SUBJECT: Contract Nonr 2788(00)X - IIT Laboratories for Omnidirectional Microwave Transistorized Crystal-Video Radio Receiving System; Report of Test of Prototype

From: Director, U. S. Naval Research Laboratory, Washington 25, D. C.  
To: Inspector of Naval Material, Fort Wayne, Indiana

Subj: Contract No. 3789(60)X - RT Laboratories for Omnidirectional  
Microwave Transistorized Crystal-Vidco Radio Receiving System  
Report of Test of Prototype

PROPOSED REJECTION RESPONSE  
FOR  
OMNIDIRECTIONAL MICROWAVE  
TRANSISTORIZED CRYSTAL-VIDEO  
RADIO RECEIVING SYSTEM

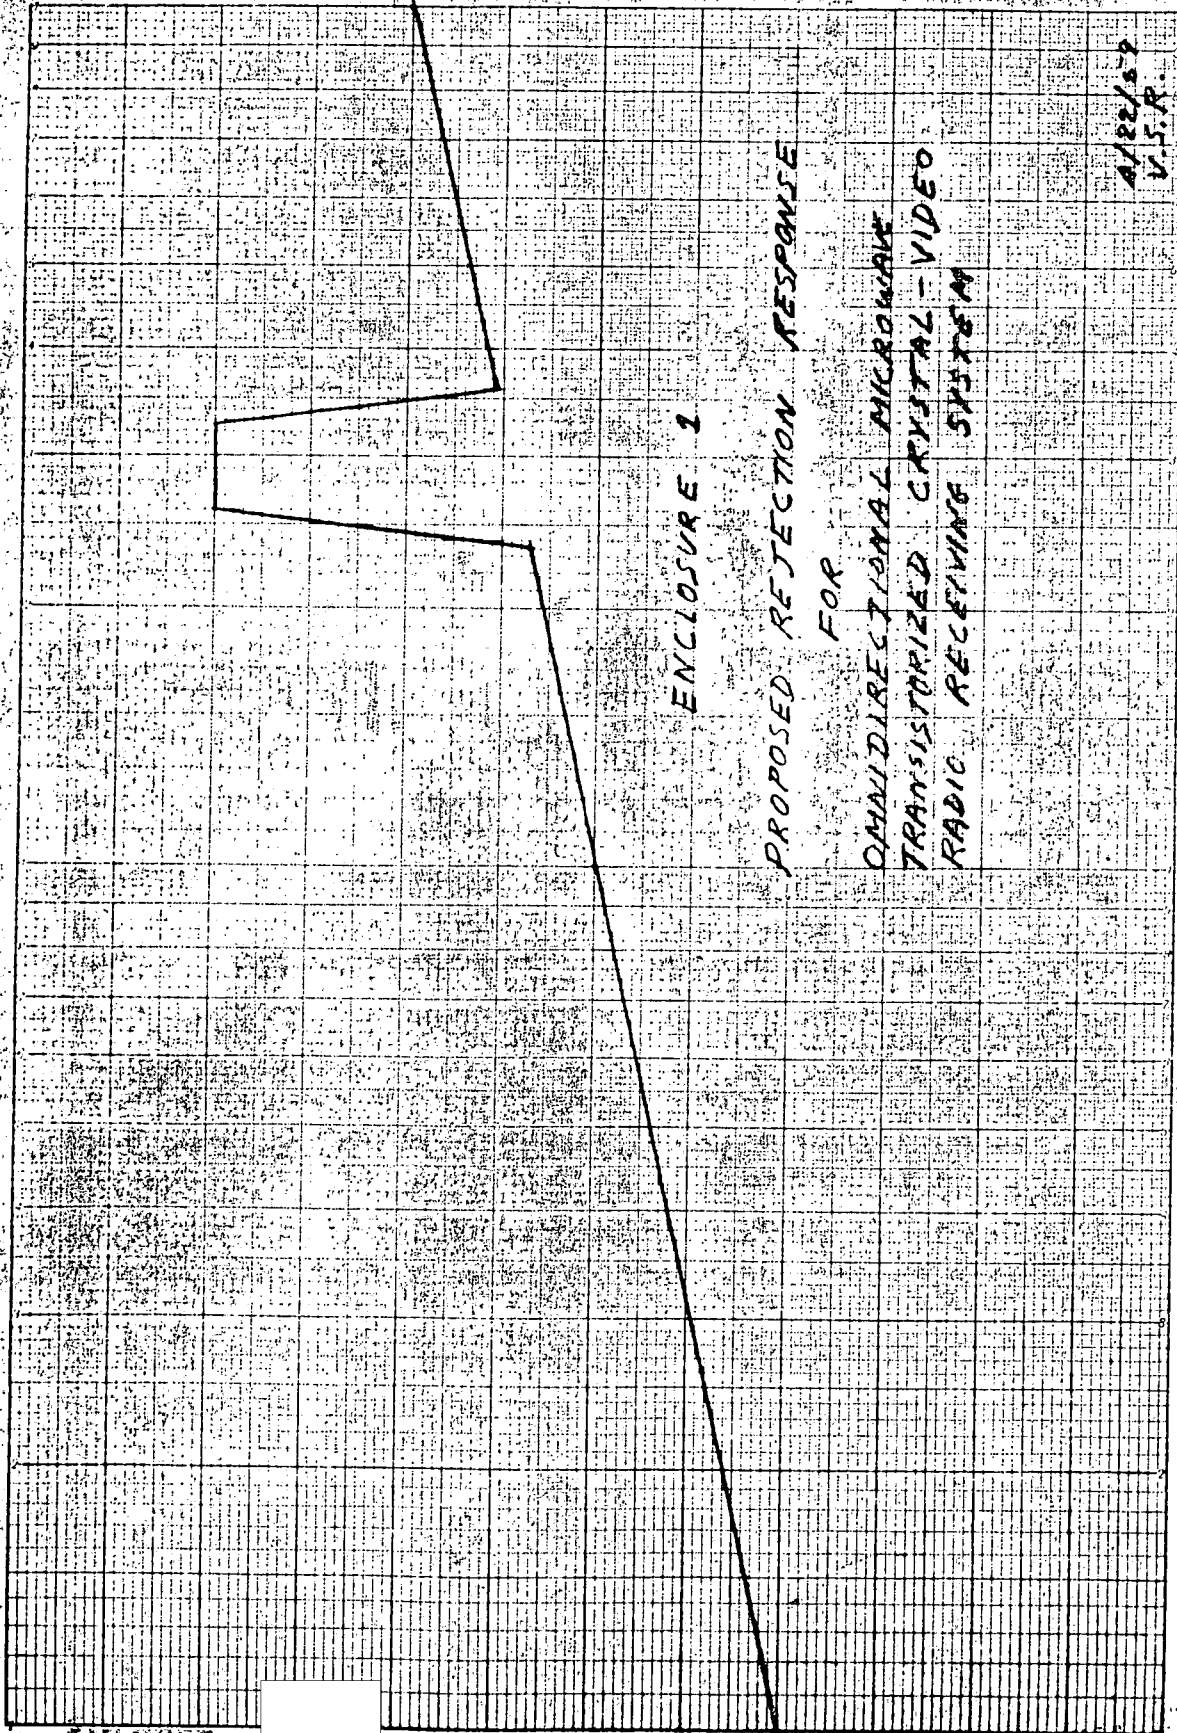
5. In giving consideration to the very minimum rejection versus frequency that it is believed could be tolerated, the Laboratory has evolved the characteristics shown by enclosure (1), copies of which are forwarded herewith. This is intended to serve as a guide to the contractor in effecting any compromise between the Acceptance and Rejection characteristics of the Filters that might be found necessary in order to permit the Sensitivity requirements to be met. However, this should not be interpreted as a premissive matter of the specified filter rejection characteristics but is indicative of the very minimum that could be considered as a separate goal necessary.
